INDESIT company

Model type:
AVL85EU

Commercial code:
F029845

1140160 Exploded views

n1040325: New shock absorber fixing system with pin

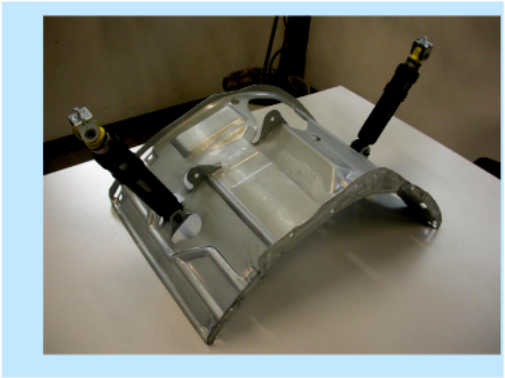
From serial no. 40427.0001, shock absorbers have been fixed to the tank unit cradle with two 11 mm pins code C00110163 (see fig. 01 and 02 enclosed) in place of the 8 mm screws code 093750 and relevant locking nuts code 030443, on all washing

machines and dryers produced in the Comunanza factory.
The items affected by this modification are:
1) The cradles have the same Service code, as they can be used in place of the new ones after widening the shock absorber fixing holes to a diameter of 10 mm.
Code 093848 - Tank unit cradle 46 lt
Code 093878 - Tank unit cradle 40 lt.
2) The new shock absorbers, with fixing bushing having no s/steel spacer, are not managed as they are interchangeable with the premodified items (make sure they are CIMA type, as the managed items), fixed with M8 screws code 093750 and related locking nut code 030443 (see figs. 05 and 06).
Code 093884 - Shock absorber 80 N
Code 093885 - Shock absorber 100 N

To remove the shock absorber from the tank, first extract the pin with a few hammer taps (see fig.03) until it is aligned with the tank bracket and then pull it out with a pair of pliers (see fig. 04).
(To refit the shock absorber use a new pin. Insert the pin until the toroidal edge is aligned with the bracket.)

Fig. n10402231

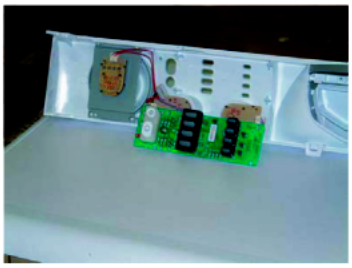
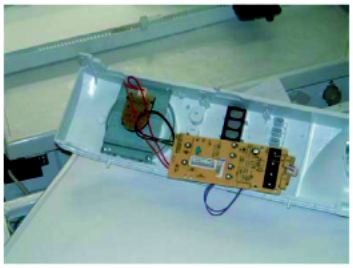
From serial no. 40429.0001, models AVL, AVXL, AVSL, AML have been equipped with a new panel with well holes for the ON/OFF and RESET buttons and flush plastic light diffusers in place of the projecting siliconed ones (see picture n10402231

Fig.02). These features determine whether an appliance is modified or premodification.
The modification has also involved the electronic card whose panel and display communication connectors are on the left and not at the back (see picture n10402232 Fig.2).

For both models
C00143338 - LED CARD EVOII AVL /BUILT-IN ARISTON
C00110115 - WHITE BUTTONS ON-OFF/RESET EVOII LED KIT
C00109854 - PANEL WIRING LBE EVOII
C00110055 - SILICONED BUTTONS AVL-AVSL
C00110059 - PANEL WIRING -DISPLAY 240000848B2.
C00111227 - WIRING MAIN - DISPLAY 24000084804B1 (POLARIZED).
The new parts are only interchangeable with the pre-modification ones if used altogether. They are not individually interchangeable.

Fig . 001

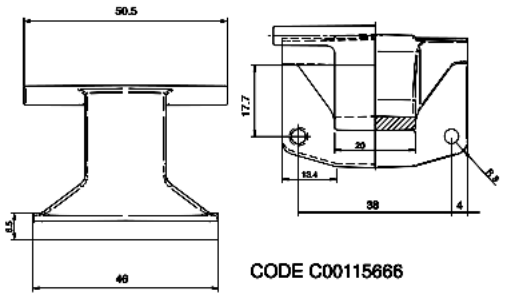
From serial no. 50207.0001, all Ariston models produced in the Teverola factory (see table 001 attached) with industrial code (given on the rating plate) starting with 46, have been equipped with a Zamac hinge with 150° opening angle, code C00115666 (see Fig.001).
This modification has involved the introduction of the following items:

Code C00115670 - Complete door EVOII 150° white 27 with standard glass;
Code C00115674 - Complete door EVOII 150° white 27 with long glass;
Code C00115667 - EVOII body for 150° hinge white 27;

The premodified items are not interchangeable separately with the modified ones.

Code C00110133 - Complete door EVOII Standard 180° white 27 standard glass;
Code C00092157 - Complete door EVOII 180° white 27 long glass;
Code C00096193 - EVOII body for 150° hinge white 27;
